ADA Curb Ramp New Construction Inspection Form (Perpendicular)

NW Main

23885.56

NW Lenox

PERPENDICULAR RAMP (PR)

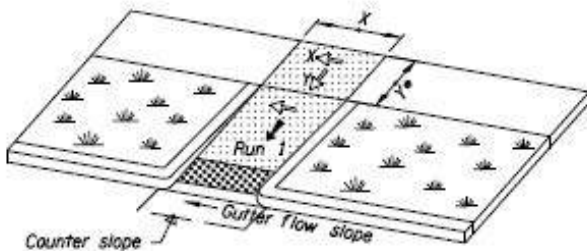
DWS IITD Fails RR 1
